## Mixed Effluent Permit

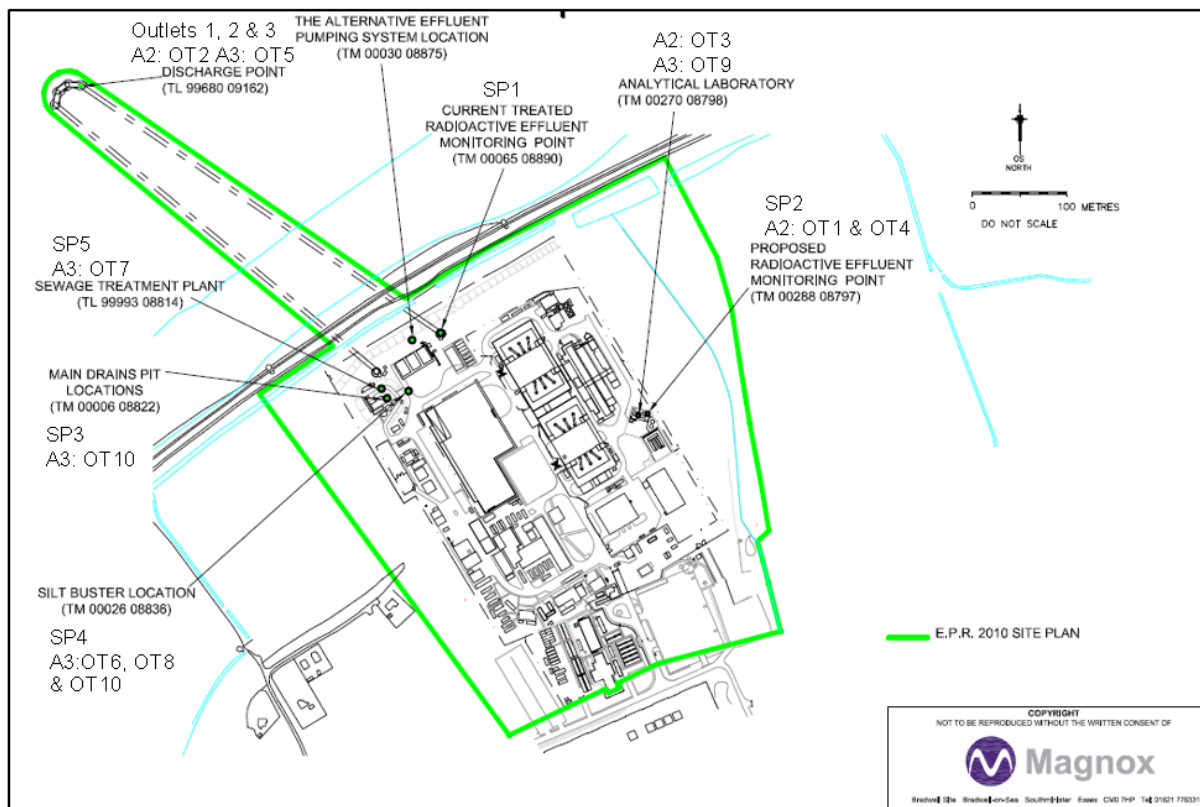
A3:OT10 is not relevant to SP4 as the OT describes the pumping arrangement from the main drains pit and not the silt buster. Therefore, A3:OT10 should be removed from SP4 (TM 00026 08836).

SP1 is the combined monitoring point currently used for the mixed effluent but it will be replaced with SP4 (voids/silt buster), SP5 (sewage treatment effluent) and SP2 (radioactive effluent) individual monitoring points. This will be significant when we switch over to the new discharge line and lose the dilution that happens at SP1.
